**CITY OF RICHLAND DEVELOPMENT SERVICES DIVISION
STAFF REPORT TO THE PLANNING COMMISSION**

PROPOSAL NAME: 1750 MCMURRAY AVENUE JASON LEE ELEM.
LOCATION: 1750 MCMURRAY AVENUE
APPLICANT: RICHARD KRASNER
FILE NO.: M2024-103
DESCRIPTION: REQUESTING APPROVAL BY THE PLANNING
COMMISSION FOR A FREESTANDING SIGN
PROJECT TYPE: MISCELLANEOUS
HEARING DATE: MARCH 27, 2024
REPORT BY: MATTHEW HOWIE, SENIOR PLANNER
RECOMMENDED
ACTION: APPROVAL, SUBJECT TO CONDITIONS

DATE: March 5, 2024
TO: City of Richland, Planning Commission
FROM: Richard Krasner, Executive Director of Operations 
SUBJECT: Jason Lee Elementary Electronic Reader Board Sign

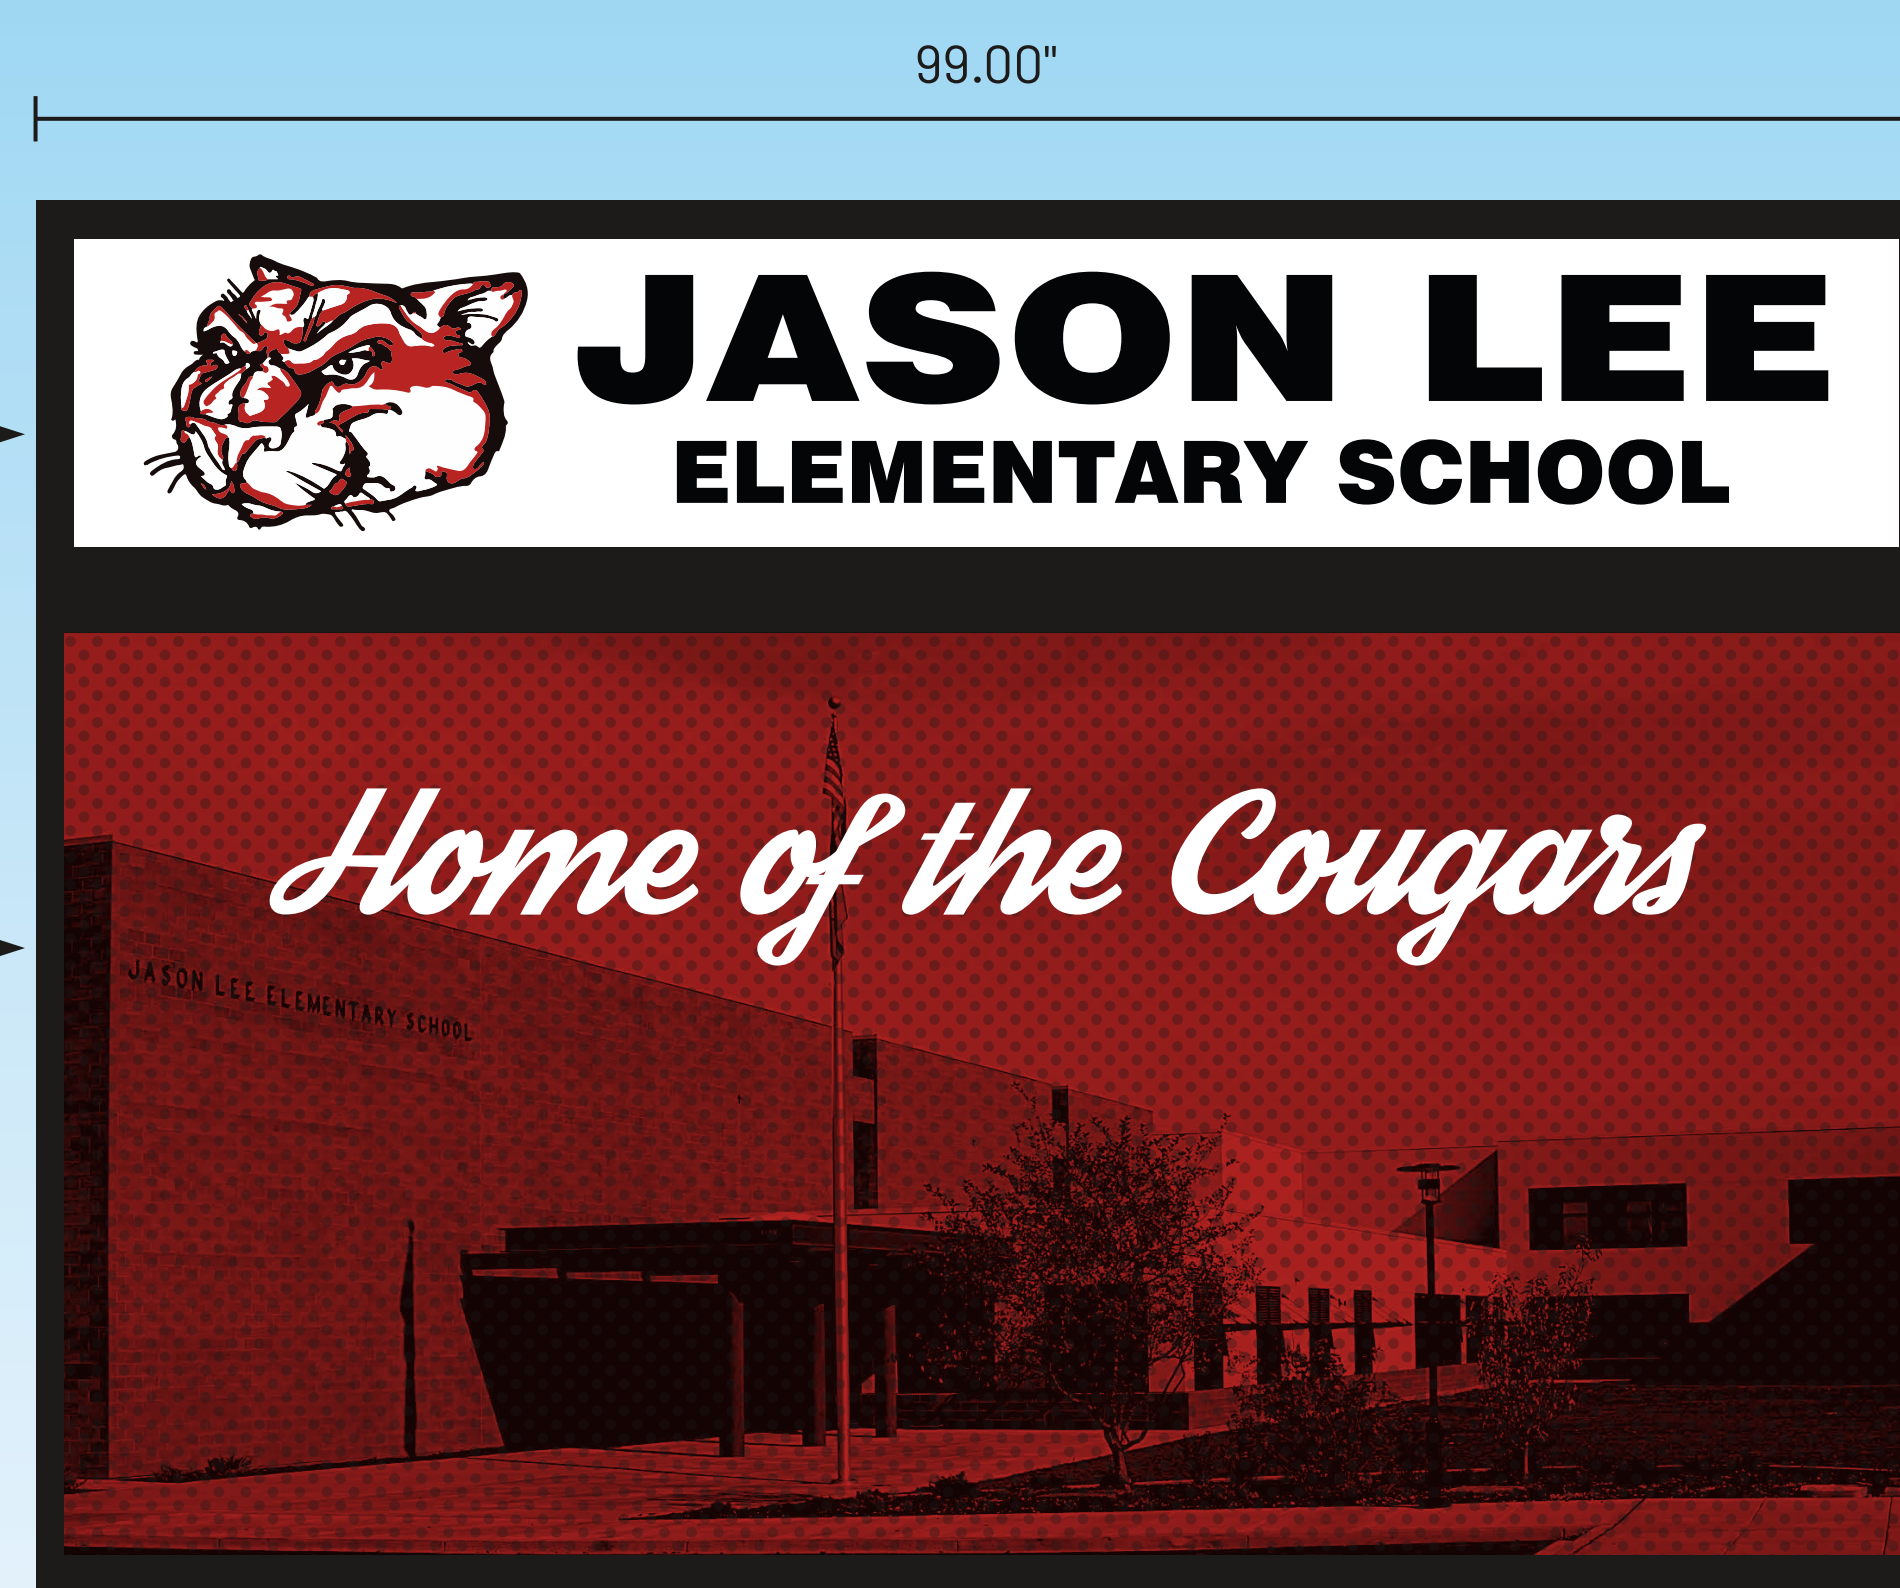
The all components of the sign, including face, base, and appurtenances shall be located at least 20' from the property line adjacent to McMurray Avenue. The current sign appears to be only a few feet from the property line.

3. The structure and attached appendages of the proposed freestanding sign shall be setback at least 20' from the property line/right-of-way associated with McMurray Avenue. The proponent currently is miscalculated the setbacks, measuring setback from the back of the sidewalk. This is not, however, the location of the property line in this area. The future location shall likewise also comply with requirements per Chapter RMC 12.11 'Intersection Sight Distance'.

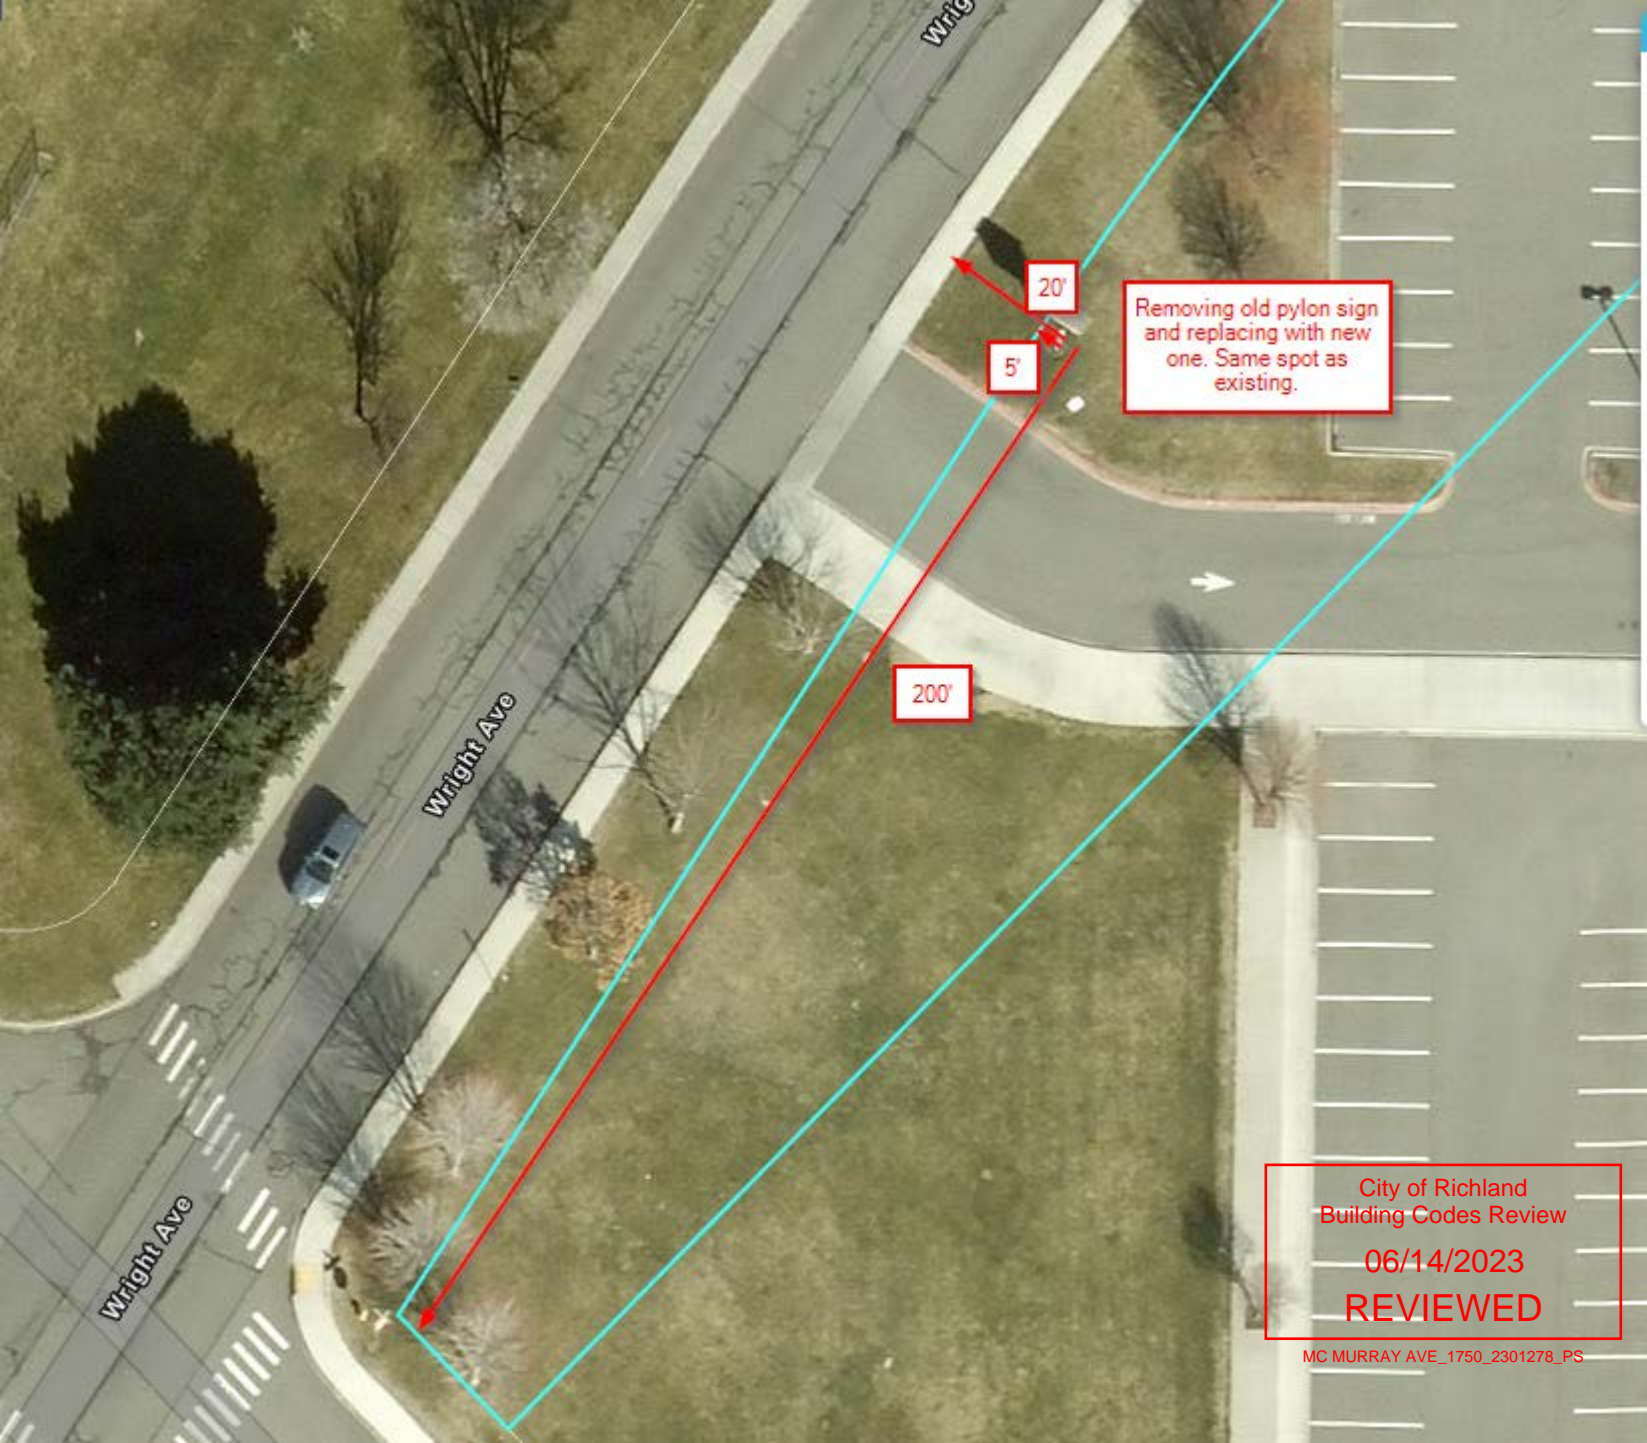
The current, proposed sign is 100.24 square feet (50.12 square feet per face) as measured by Staff. Each face shall be 32 square feet or less in order to meet this requirement. Approval will be conditioned so that both faces measure no less than or equal to 64 square feet (32 square feet per face).

1. Signage shall not be more than 64 square feet in size (32 square feet per face)
2. Signage shall not be more than 20 feet tall as measured from the grade plane to the top of the sign structure.
